Historic Preservation Commission

May 28, 2020

1720 3rd Avenue SE – Window and Door Replacement

Sample Window

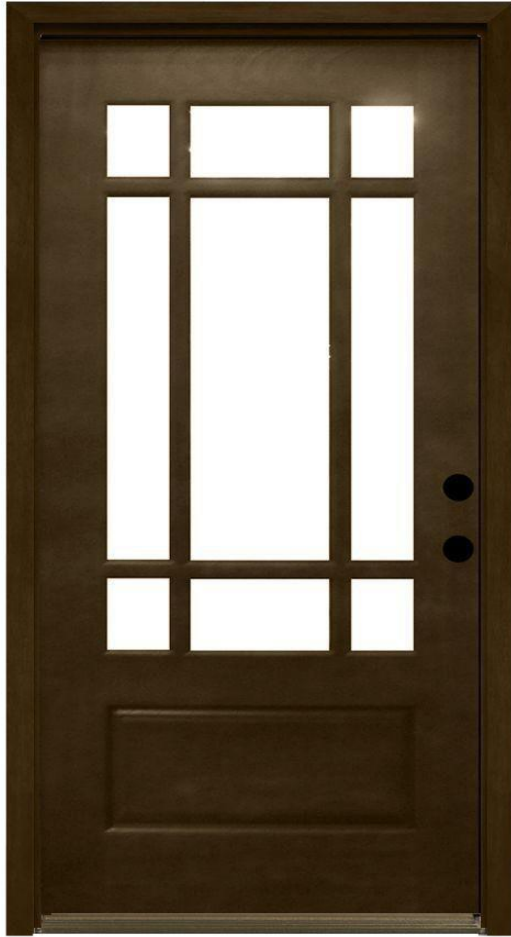
- Home built in 1921
- Located in the 2nd and 3rd Avenue Historic District
- The applicant would like to replace 14 windows on the enclosed front porch, to make it a four seasons porch. The proposed window would be a wood window with a similar sash pattern as the original window with thin aluminum cladding on the front side
- The applicant would also like to replace the front porch door with a new wood door

- Windows constructed of modern building materials, such as vinyl or aluminum on the front and sides of homes
- Decreasing the size of the window opening
- Altering window openings on front facades or side facades visible from the street to accommodate new windows of different size, proportion or configuration.
- Adding window openings that are not original to front facades or elevations visible from the street.
- Altering character defining window openings on all facades.
- New windows on front facades and sides visible from the street with snap-in or flush muntins.
- Enclosing or concealing basement windows on the exterior.

- Staff recommends approval of the COA for the windows because the Design Guidelines allow for wood windows with aluminum storm windows and these proposed windows match the design as closely as possible.
- Staff also recommends approving the COA for the door because the guidelines allow replacement wood doors.
